Iditarod Dog Sledding Historic District Meeting

Wednesday, January 11, 2012

Iditarod Dog Sledding Historic District (IDSHD) Workshop Workshop Summary and Implementation Plan Comment Resolution Summary

Figure 1: Crossing constraints

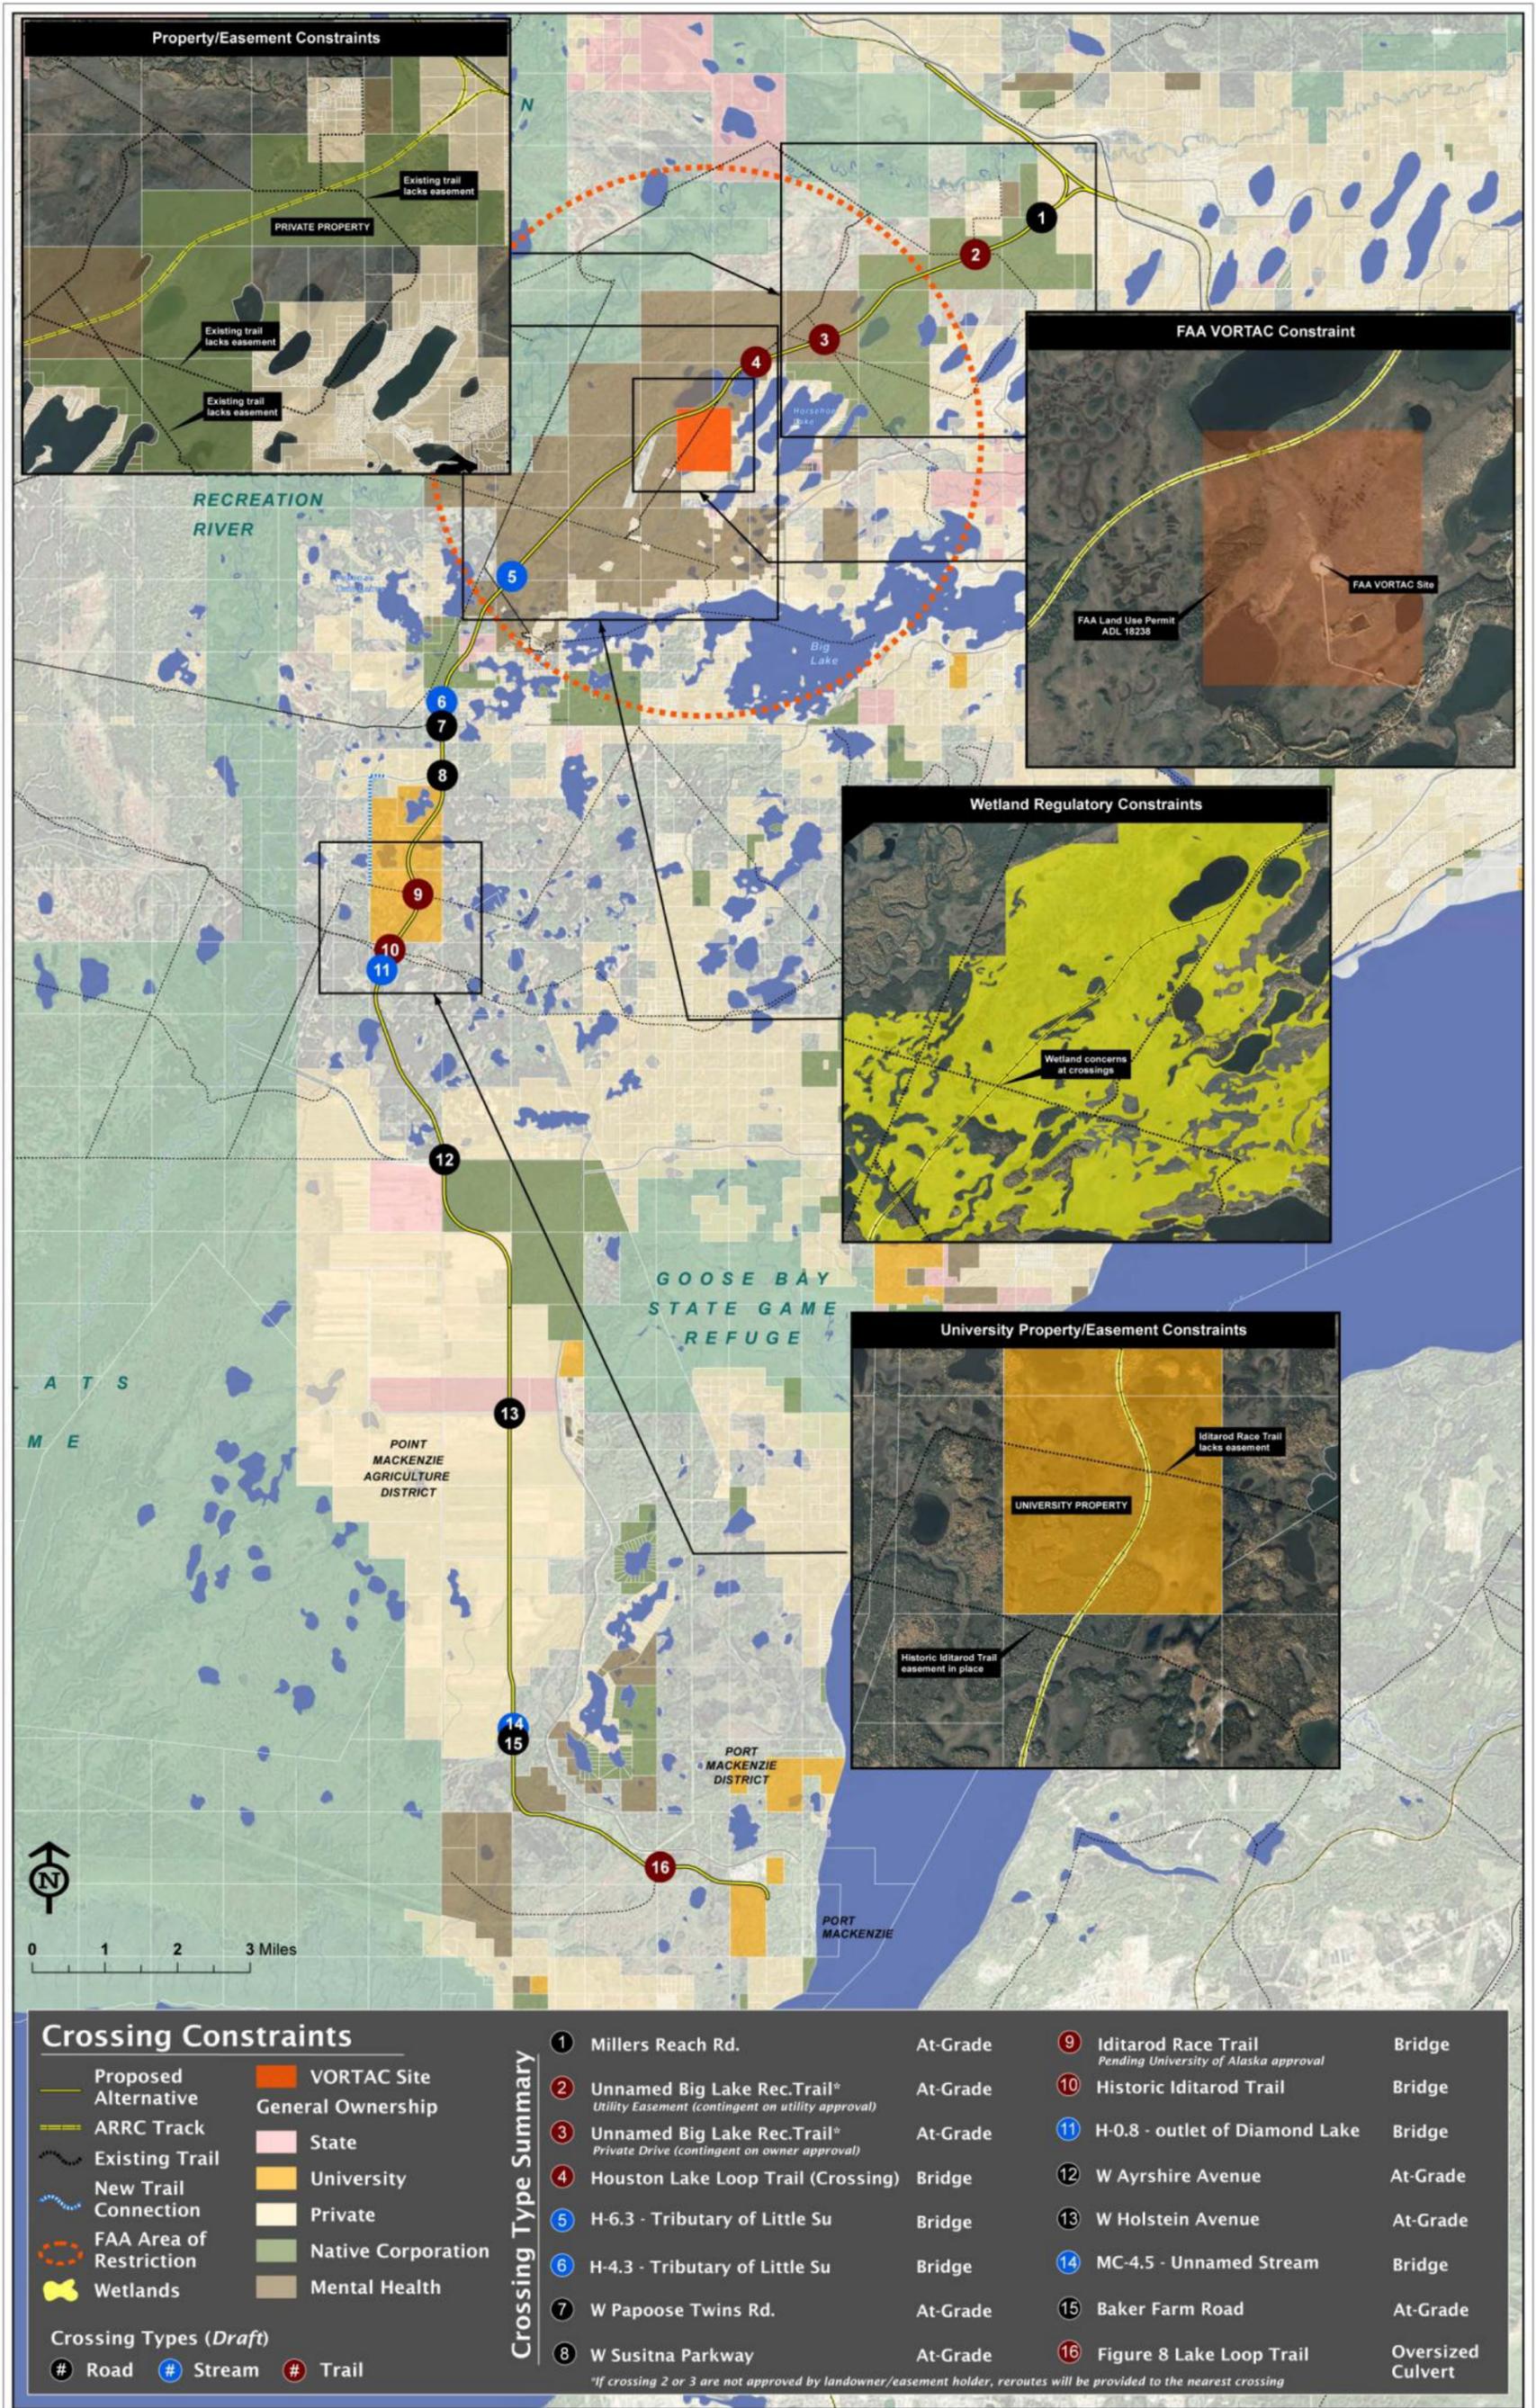
6. *Provide a map to workshop participants showing where crossings cannot be located (e.g., VORTAC or wetland restrictions or other design concerns).*

Proposed Resolution: A map showing restrictions/constraints limiting crossing locations was available at the MSB Trail User Open House (10/27/11). This map was posted on the

project website (http://www.portmacrail.com/maps/Constraints_v2%20web.jpg) and is included in this document (see Figure 1 in Attachment 1).

Crossing Vertical Clearance

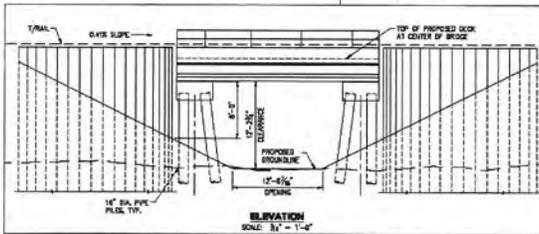
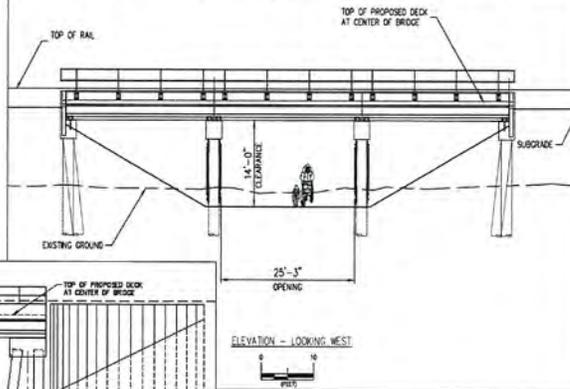
The height (vertical clearance) of crossings needs to be increased to more than 12' to account for snow depth, accommodate equipment for grooming of trails, and enhance safety. The existing clearance is as low as 10' for some crossings.

Vertical clearance increased to a minimum of 14' whenever possible

Line of Sight

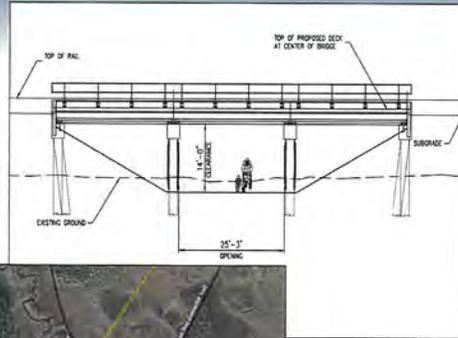
Some crossings are single span bridges and do not provide mushers with adequate visibility to see if anything is approaching from the other direction. The length of these crossings needs to be increased. Trail approaches to crossings also need adequate line-of-sight.

- Minimum of 3-spans
- Generally provide 20' horizontal clearance (minimum)
- Adequate line-of-sight provided by relatively straight approaches

Crossing 5 (H 6.3) profile view.

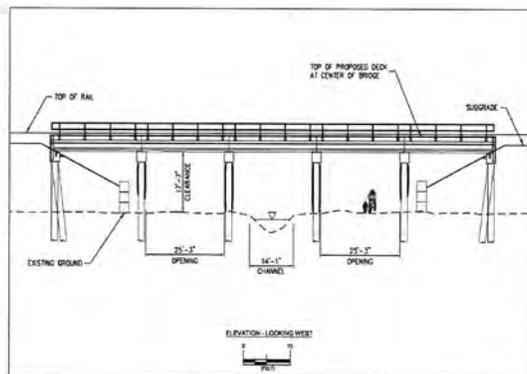
Comment 10:

- Trail on both the north and south side of the creek
- 25'+ horizontal clearance to accommodate multiple users and grooming equipment
- 17'+ vertical clearance
- Sufficient line-of-sight
- Approaches with gentle curves (75'-90' radii)
